# N° 139-682

ATA 24 - AUXILIARY OVERHEAD PANEL AND INTERSEAT CONSOLE MODIFICATIONS

This Service Bulletin is issued in order to provide the necessary instruction on how to perform the installation of AUX O/H panel retromod P/N 3G2460P01027 and Interseat Console variant P/N 3G0630P29311.

S.B. N°139-682 DATE: January 10, 2023 REVISION: / Figure 1

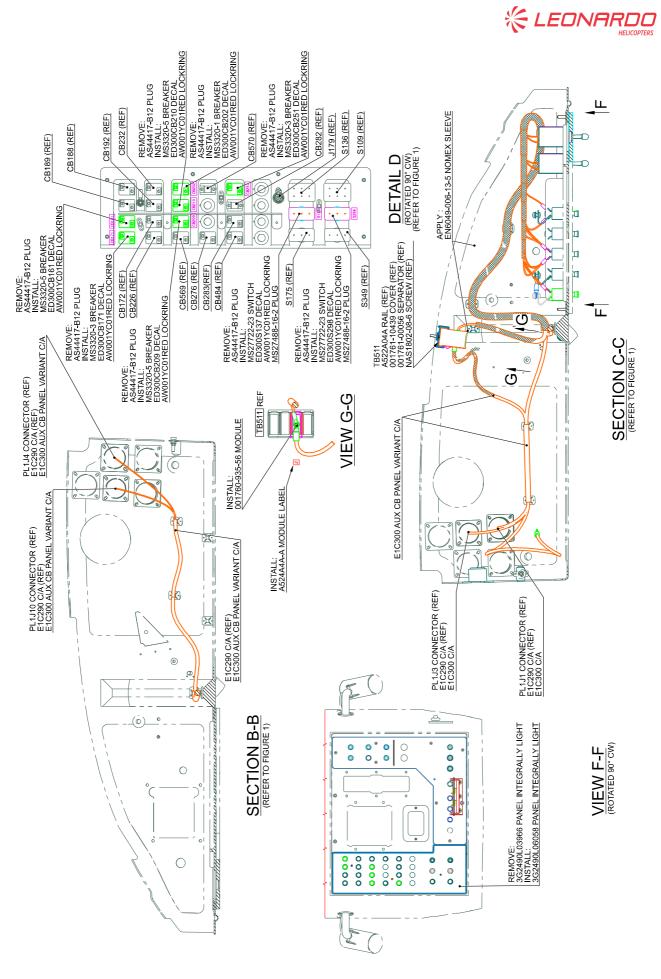
- 2.1 With reference to Figure 1 Detail A and Detail J, install the bus bar P/N 1035685-22 (W22D) on the O/H panel by means of the screw P/N NAS1802-3-7, the locking washer P/N MS35338-138 and the washer P/N NAS1149C0332R.

- 2.6.5 Perform a pin-to-pin continuity check of all the electrical connections made.
- 2.7 With reference to Figure 1, protect the cable assy E1C300 (wire 600-8) by means of nomex sleeve P/N EN6049-006-05-5.

- 2.8 With reference to Figure 1, protect the cable assy E1C290 (wires 800-8, 900-8) by means of nomex sleeve P/N EN6049-006-13-5.
- 2.9 With reference to Figures 1 and 2, protect the cable assy E1C300 by means of nomex sleeve P/N EN6049-006-13-5.

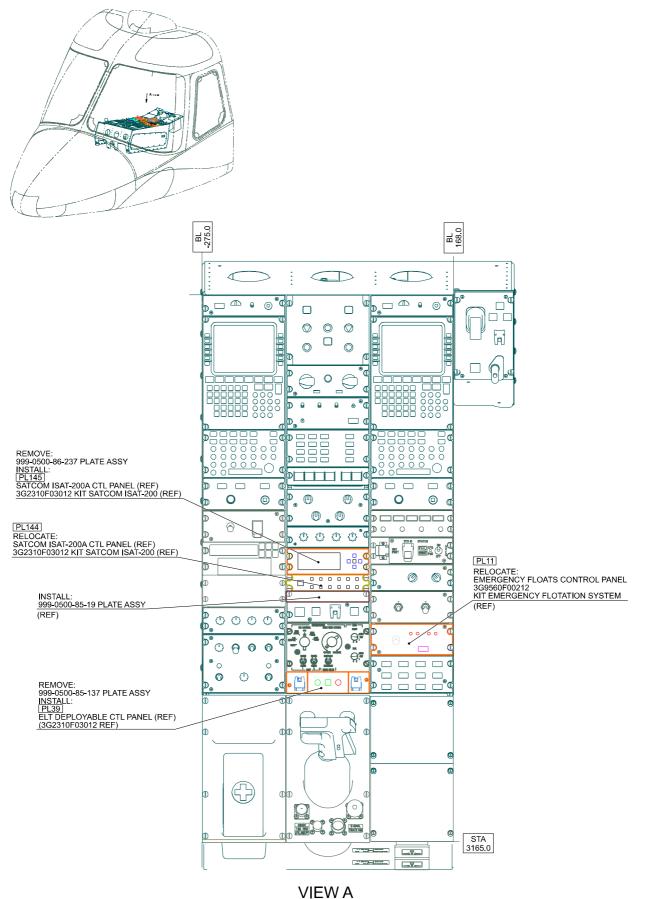
- 2.2 With reference to Figure 2 Detail D, remove n° 8 plugs P/N AS44417-B12 from the O/H panel.

- 2.3 With reference to Figure 2 Detail D and in accordance with applicable steps of DM 39-A-24-97-02-00A-921A-A (circuit breakers), DM 39-A-24-97-03-00A-921A-A (switches) and DM 39-A-11-00-01-00A-720A-A (decals), install the following components on the O/H panel:

- n° 8 decals P/N ED300CB161, P/N ED300CB171, P/N ED300CB202, P/N ED300CB209, P/N ED300CB210, P/N ED300CB251, P/N ED300S137, P/N ED300S298.
- 2.4 With reference to Figure 2 View G-G, install the terminal board module P/N 001760-935-56 and the identification label P/N A524A4A-A on the TB511.

- 2.5 With reference to Figure 2 View F-F and in accordance with DM 39-A-24-91-04-00A-920A-K, replace the existing panel integrally light with the new panel integrally light P/N 3G2490L06058.

#### Figure 3

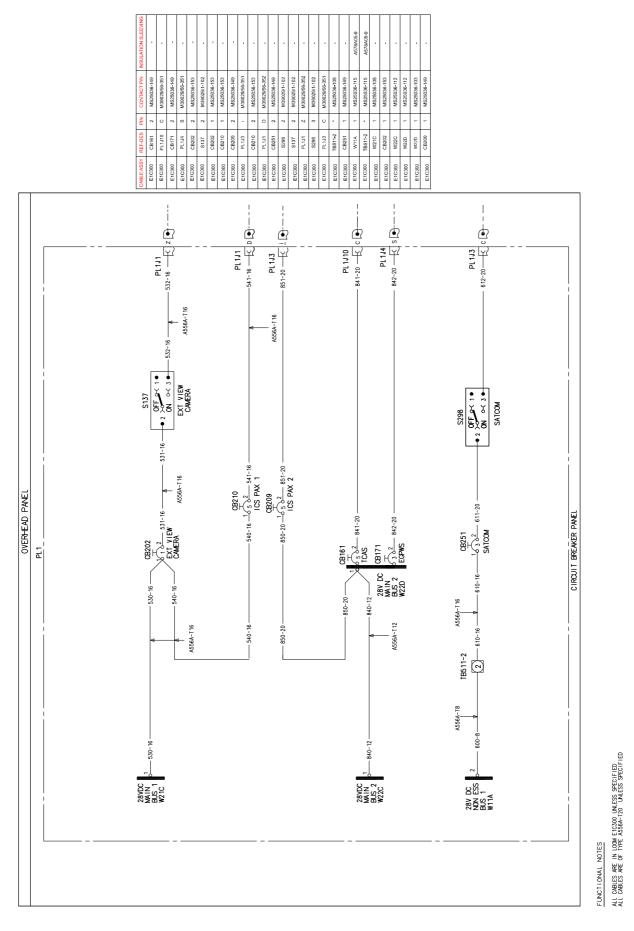
- 3.1 With reference to Figure 3 View A, replace the plate assy P/N 999-0500-85-137 with the ELT deployable control panel (PL39).
  - 3.2 With reference to Figure 3 View A, replace the plate assy P/N 999-0500-86-237 with the satcom ISAT-200A control panel (PL145).

- 3.3 With reference to Figure 3 View A, relocate the satcom ISAT-200A control panel (PL144) and the Emergency floats control panel (PL11) on the IS console.

- 3.4 With reference to Figure 3 View A, install the plate assy P/N 999-0500-85-19 on the interseat console.
- 4. In accordance with DM 39-A-46-20-00-00A-750A-A, install the option file P/N DM60004869-60203.
